Technical	Serv	ice Bulletin			
Date Issued Model Year(s) Affected		ted	Model(s) Affected		1	TSB #	
	1/3/2007 12/2/2005 - 5/9/2006		2006	All Star		311	
		Brand				Туре	
All	C	American Star		Mountain Aire		All 🗖	ТТП
		Dutch Star		Kountry Aire		FW 🗖	САП
All	Star	Kountry Star		Essex		D P 🗖	DB□
Sco	ttsdale 🛛	Northern Star		London Aire		D1 –	
□ Air Conditioning & Heating			Electrical Components				
	Appliances & Acc	ressories	[Exterior Components			
□ Cabinets & Furniture □			Interior Components				
■ Chassis Components □ I			Plumbing & Bath Components				
Construction Components			[□ Windows, Awnings, Vents, & Doors			
		Descri	iption of I	Problem			
Pote	ential for Driveline	Vibration.					
		Recom	mended	Solution			
-		the rear engine mounts, and nufacturer directly for addit		-		's attached	l repair

Re: Notice of Campaign Service Bulletin: CSB06-170-002

CAMPAIGN SERVICE BULLETIN

<u>SUBJECT</u>: Engine -Mounts

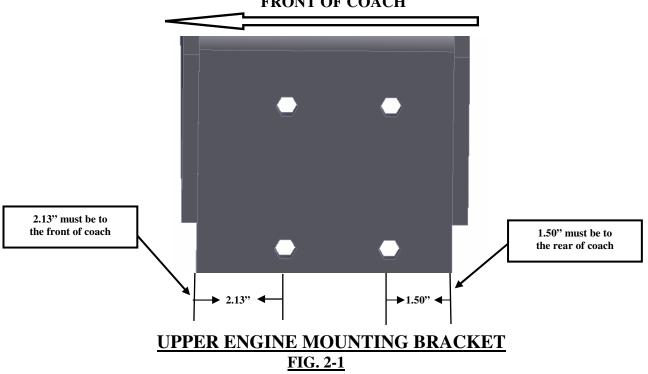
2. Refer to FIG. 2-1. Measure the bolt hole location on the vertical surface of each rear upper engine mounting bracket.

- 2a) From the rear vertical edge of the bracket, measure to the centerline of the first hole. If the dimension is 1.50" the mount is installed properly and no further work is necessary.
- 2b) If the measurement is not 1.50" proceed to step #3.

NOTE: The measurement should be the same for both brackets. If the measurement is not the same, contact Spartan Chassis, Inc.

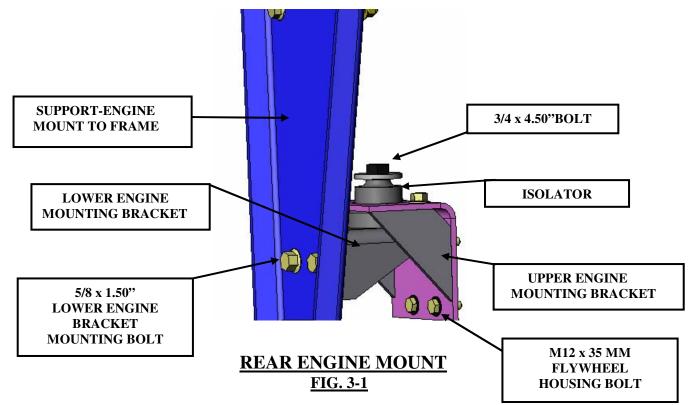
- 4. Refer to FIG. 3-1. Remove 3/4 X 4.50" bolts that pass thru the engine mounting brackets and isolators. Save fasteners for reuse.
- 5. Remove 5/8 X 1.50" bolts from support frame brackets. Save fasteners for reuse.
- 6. Remove M12 X 35MM bolts from upper engine mounting bracket and isolator as an assembly from each side of flywheel housing. Save fasteners for reuse.
- 7. Remove all of the threadlocker from the threads of the bolts that were attaching the upper engine mounting brackets to the flywheel housing.

8. Install upper engine mounting bracket and isolator assemblies such that the bolt hole location of the first hole from the rear vertical edge is 1.50" as described in step #2. Apply a liberal amount of thread locker. Reuse existing hardware. Torque to 38 ft. lbs.
